VIRGINIA DEPARTMENT OF TRANSPORTATION PRINCE WILLIAM LAND USE PROJECT REVIEW COMMENT AND RESOLUTION SHEET				TIA NOT REQUIRED		COMMENT CATEGORIES: 1. REQUIREMENT 2. RECOMMENDATION 3. CLARIFICATION	
COUNTY PROJECT NUMBER: CPA 2021-00004			DEVELOPER/ENGINEER: MARY ANN GHADBAN / CHRISTOPHER CONSULTANTS		REVIEWER(S): ERIK SPENCER, P.E. ERIK.SPENCER@VDOT.VIRGINIA.GOV		DATE: 03/11/22
PROJECT NAME: PW DIGITAL GATEWAY			REVIEW PHASE & TYPE: 1ST REVIEW, CPA		DISCIPLINE: VDOT

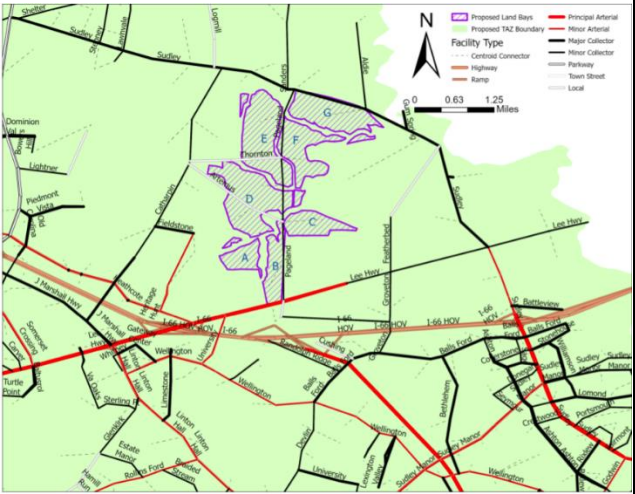
1.08	TIA	Chapter 536: Please provide a table showing the existing and planned roadways with minor arterial or above functional classification, which have a volume exceeding capacity as a result of this project.	1

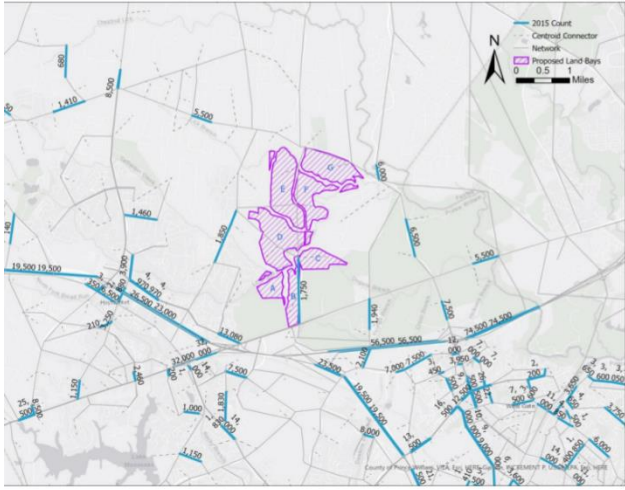
VIRGINIA DEPARTMENT OF TRANSPORTATION PRINCE WILLIAM LAND USE PROJECT REVIEW COMMENT AND RESOLUTION SHEET			TIA NOT REQUIRED		COMMENT CATEGORIES: 1. REQUIREMENT 2. RECOMMENDATION 3. CLARIFICATION
COUNTY PROJECT NUMBER: CPA 2021-00004		DEVELOPER/ENGINEER: MARY ANN GHADBAN / CHRISTOPHER CONSULTANTS		REVIEWER(S): ERIK SPENCER, P.E. ERIK.SPENCER@VDOT.VIRGINIA.GOV	DATE: 03/11/22
PROJECT NAME: PW DIGITAL GATEWAY		REVIEW PHASE & TYPE: 1 ST REVIEW, CPA		DISCIPLINE: VDOT	
ITEM NO.	DWG. No.(1)	COMMENTS	COMMENT CATEGORY	RESPONSE(2) DATE:	FINAL DISPOSITION(3)
1.12	TIA	<p>Page 4: Figure 2: 2015 Network Facility Types:</p> <p>A portion of Lee Hwy is not identified as “principle arterial” near Sudley Road, Battlefield Park. Why is it not a “principal arterial”? Please explain.</p>  <p style="text-align: center;">FIGURE 2: 2015 NETWORK FACILITY TYPES</p>	1
